SUBJECT: POTENTIAL GENERIC ISSUE CONCERNING RING SETTINGS OF
 CROSBY SAFETY VALVES

SUBJECT: IE NOTICE REGARDING MAIN STEAM SAFETY
VALVE TEST FAILURES AT WYLE LABORATORIES

IE Information Notice No.: 85-xx MAIN STEAM SAFETY VALVE TEST FAILURES AND RING SETTING ADJUSTMENTS

IE INFORMATION NOTICE NO. 86-05: MAIN STEAM SAFETY VALVE TEST FAILURES AND RING SETTING ADJUSTMENTS

FIG. 1

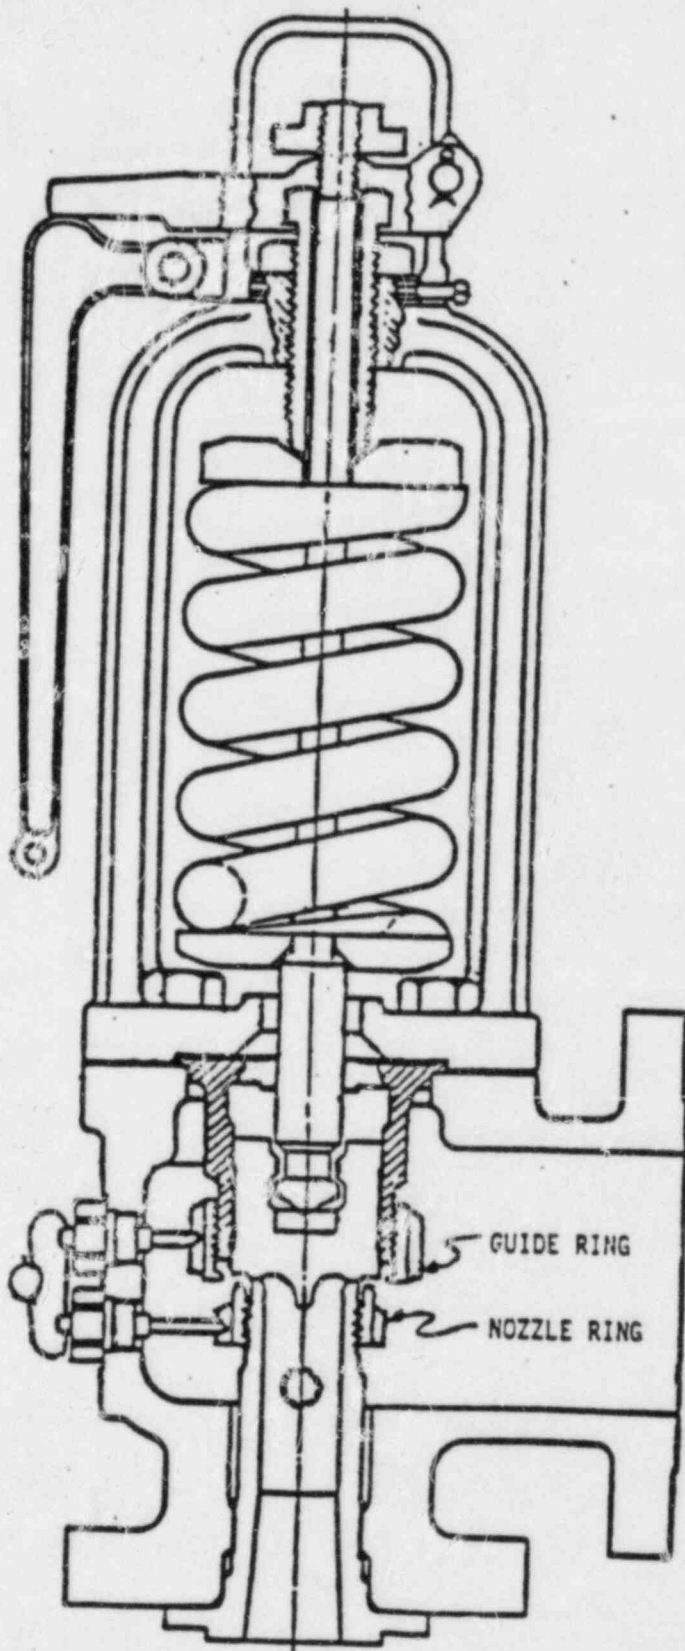
This Information Notice is being provided as a notification of a potentially significant problem pertaining to spring-actuated main steam safety valves (See Figure 1), that may possess less than the full rated flow capacity required for overpressure protection of the secondary cooling system in PWRs. It is expected that recipients will review the information for applicability to their facilities and consider actions, if appropriate, to preclude a similar problem at their facilities. However, suggestions contained in this Information Notice do not constitute NRC requirements; therefore, no specific action or written response is required.

FIG. 1
TYPICAL MAIN STEAM SAFETY VALVE

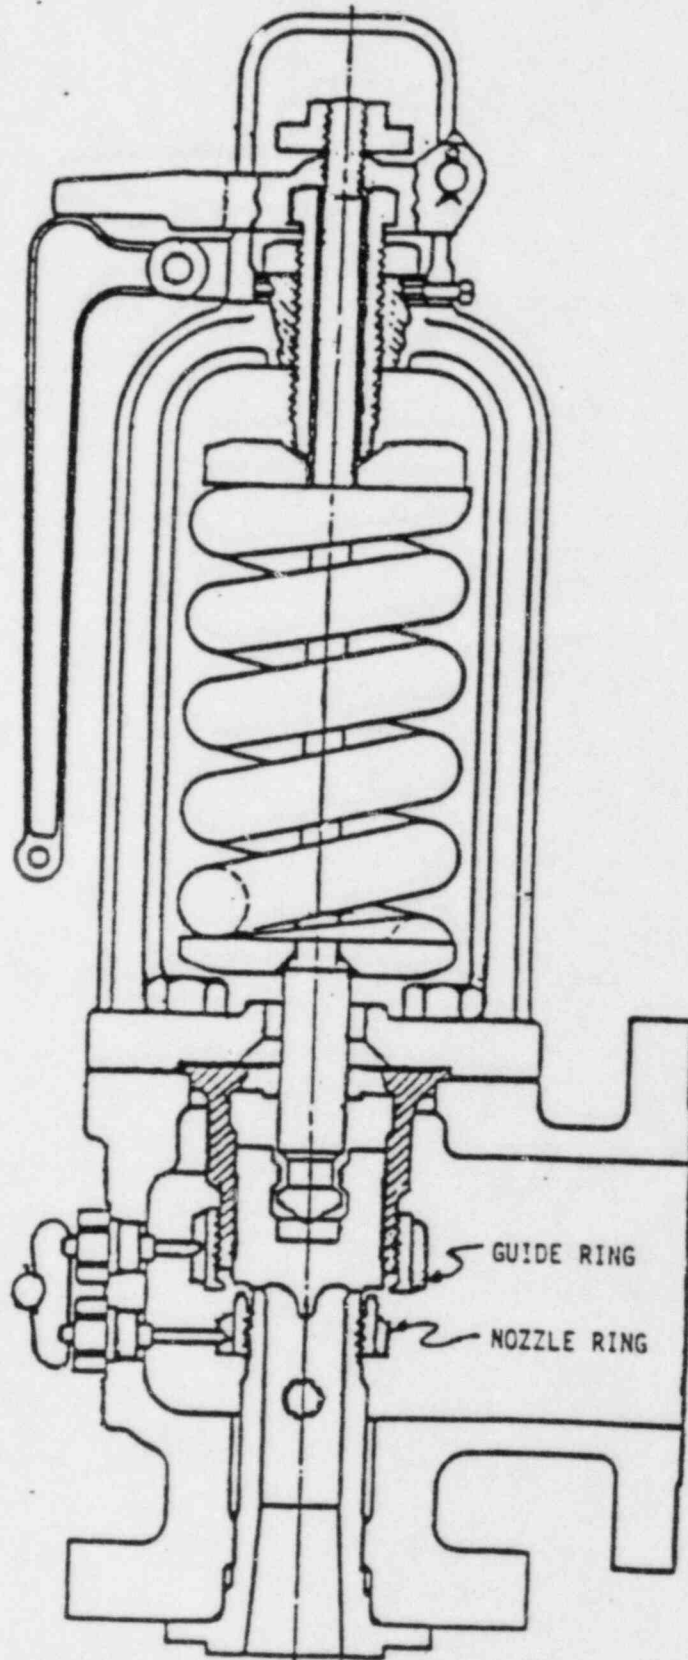
licensee consulted with the valve manufacturer and agreed on ring settings of +25 for the guide ring and -25 (the original setting) for the lower (nozzle) ring (see figure 1).

FIG. 1

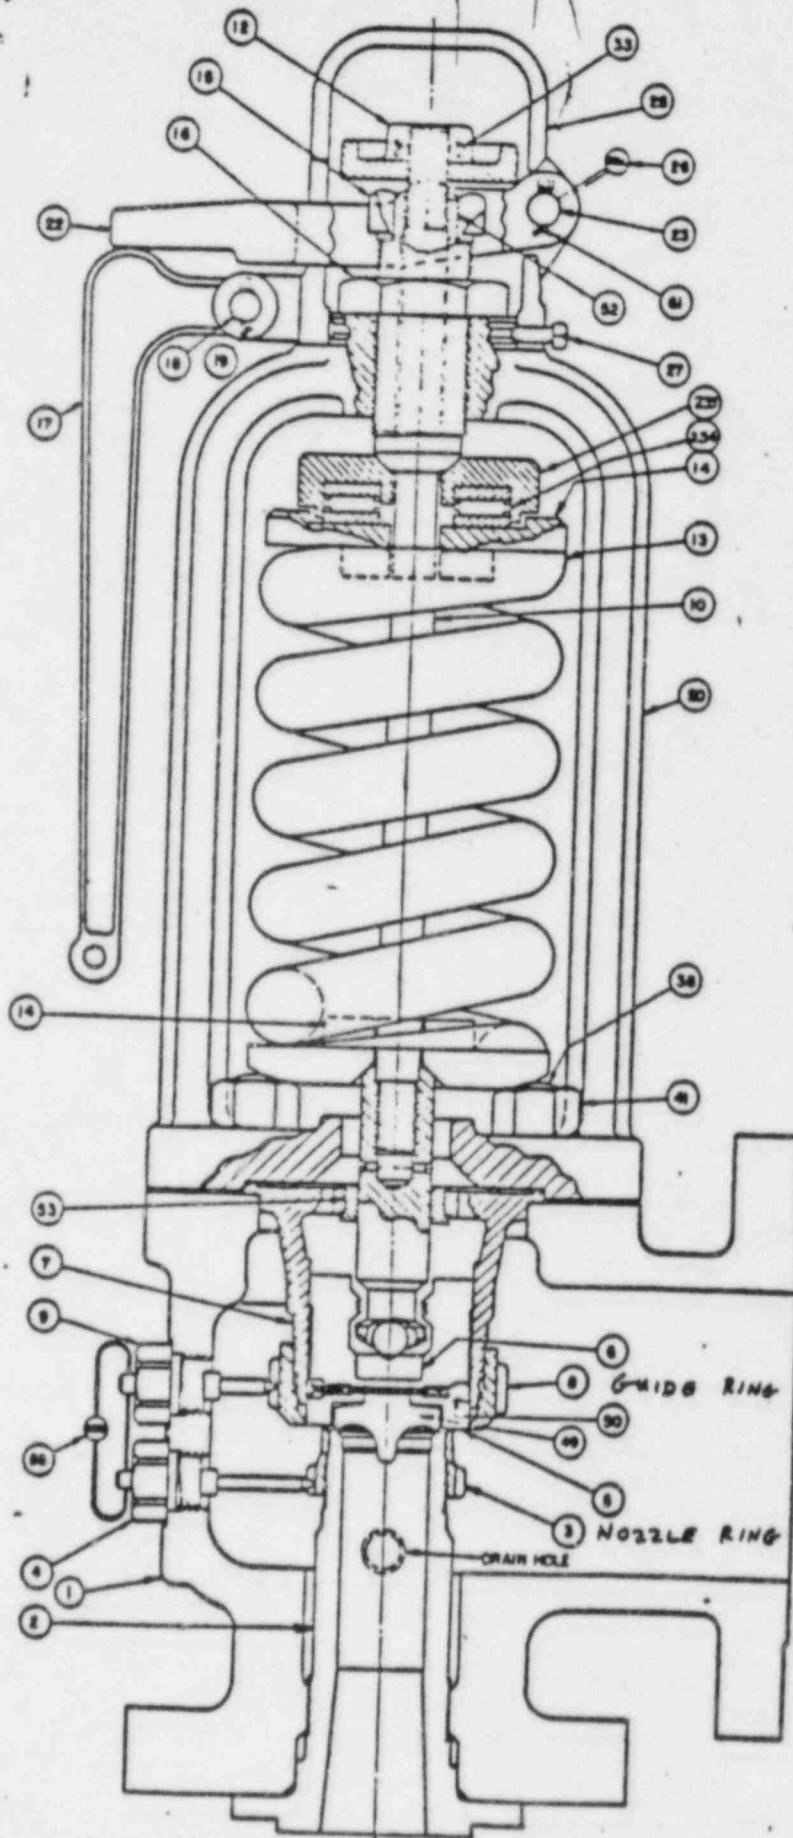
This information notice is being provided as a notification of a potentially significant problem pertaining to spring-actuated main steam safety valves ^(see Figure 1) ~~(see Figure 1)~~, that may ~~not~~ possess less than ^{the} full rated flow ^{capacity} ~~capacity~~ required for overpressure protection of the secondary cooling system in PWRs.
